Village of Chenequa Plan Commission  
Monday, June 9, 2025 at 6:00 p.m.  
31275 W. County Road K, Chenequa, WI 53029

## STAFF REVIEW

**Subject:** Site Plan Review

**Project Description:** Proposed Accessory Structure

QUADRACCI FLORES  
ENTRY PILLAR PLAN REVIEW  
CHENEQUA, WI

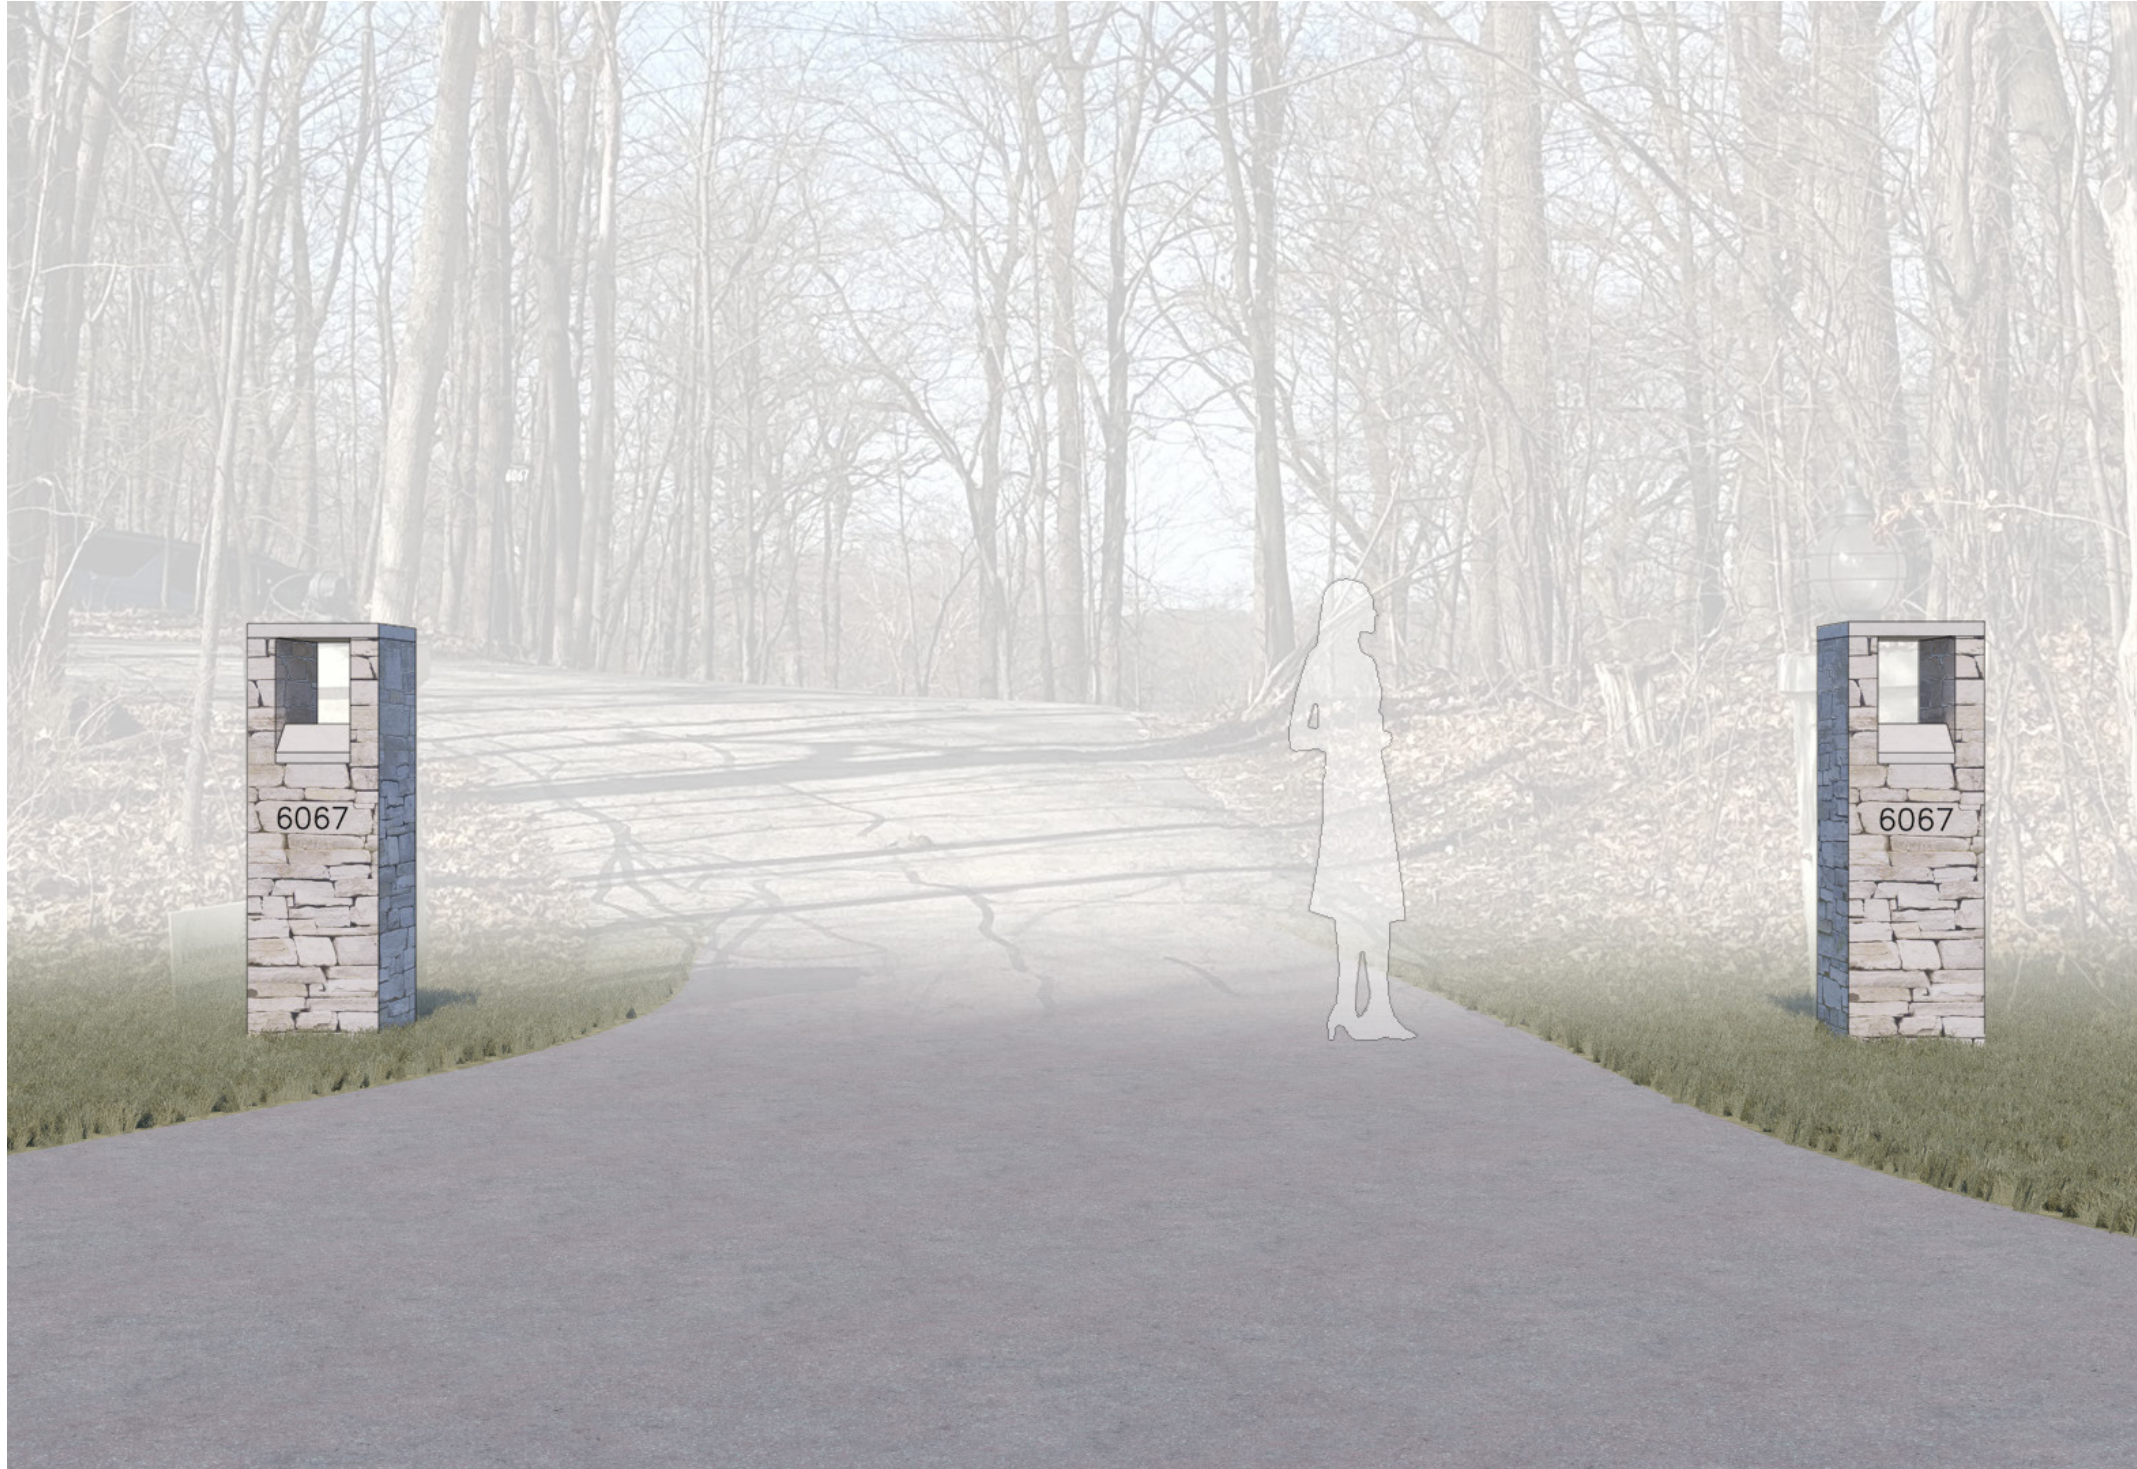
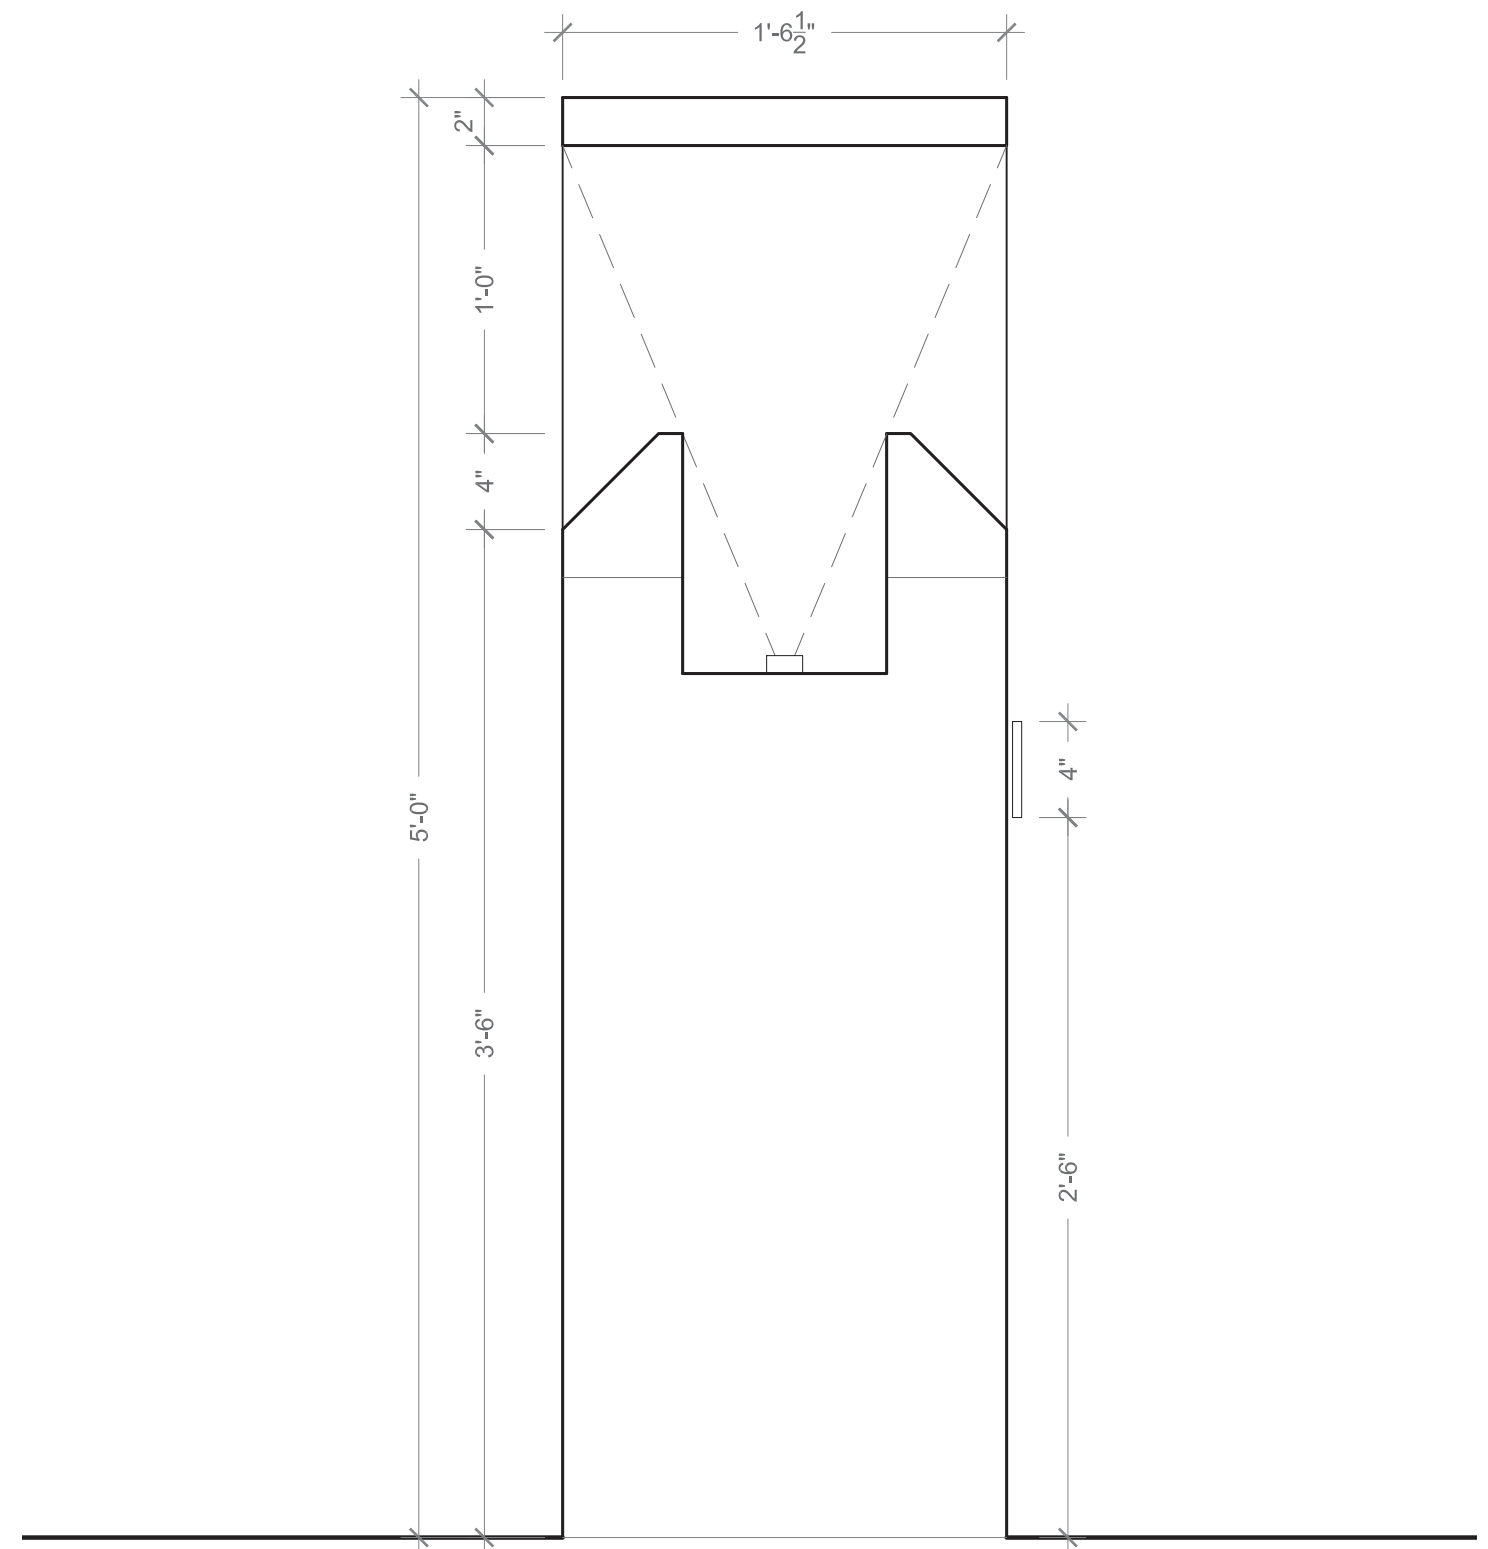
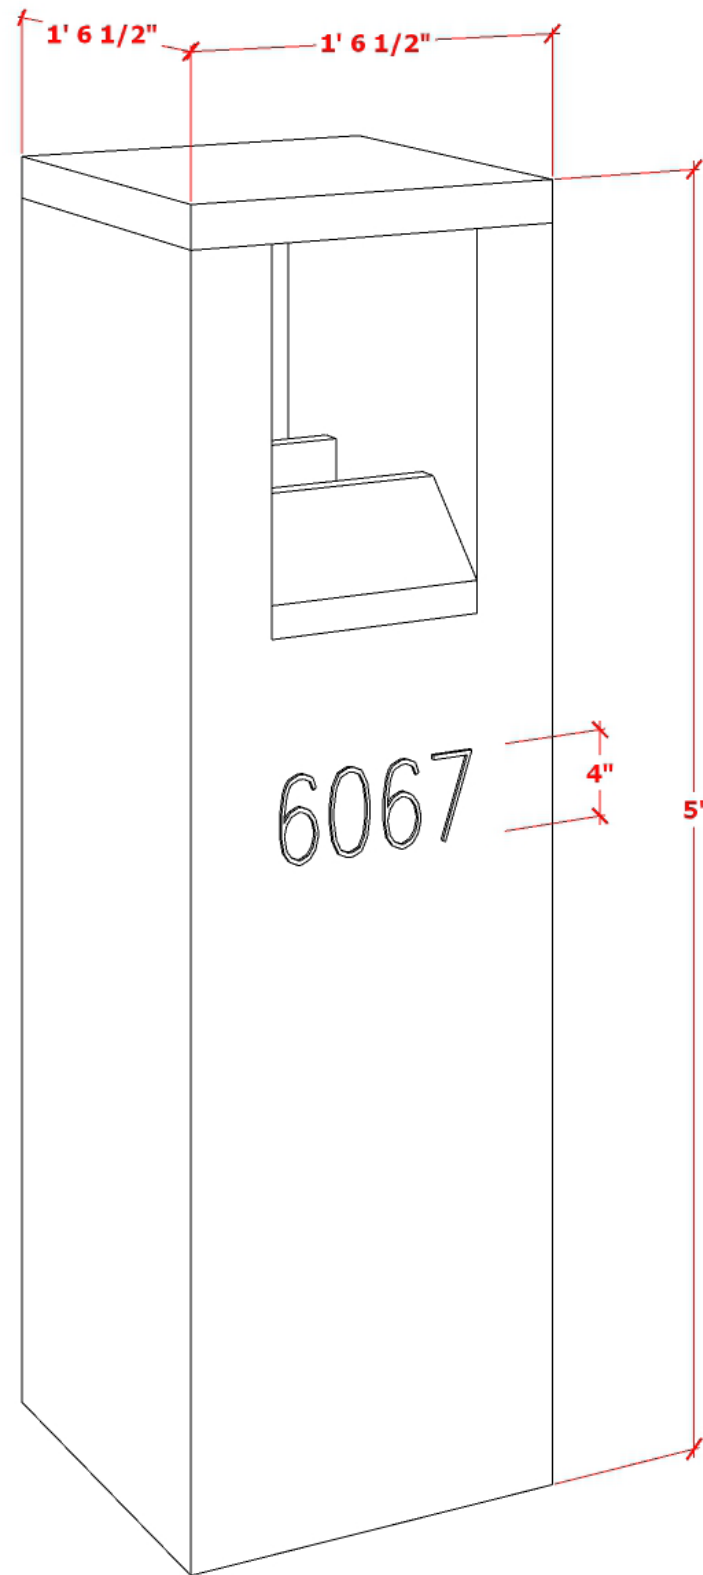
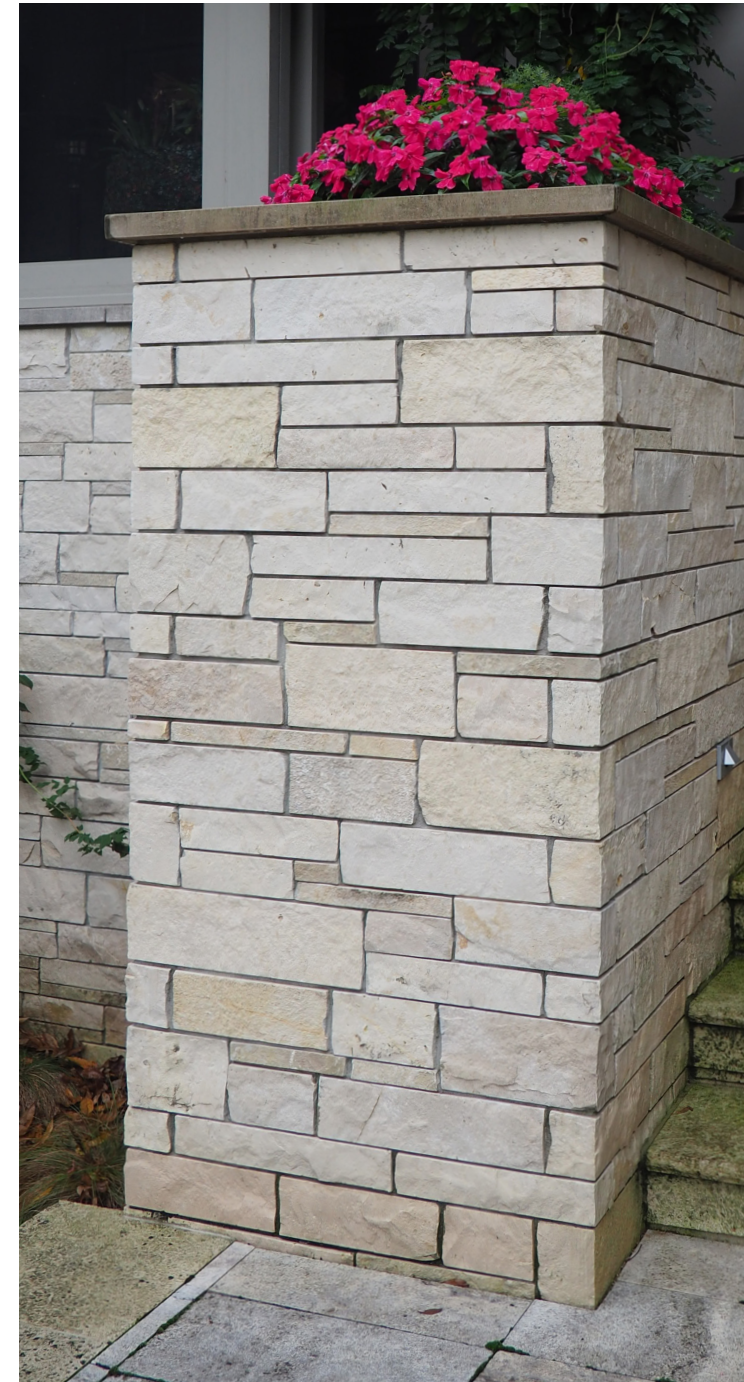
1. The applicants are proposing to replace existing entryway pillars that are currently adjacent to STH 83
2. According to 5.20(1) *“All permit applications shall be referred to the Plan Commission and shall be considered as to appearance, materials, design, location, height and harmony of the proposed fence with the principal structure on the lot and structures on neighboring lots so as not to adversely affect property values in the neighborhood.”*

4. The proposed project meets all other requirements of Village of Chenequa Zoning.
5. A building permit is required from the Building Inspector prior to start of construction.
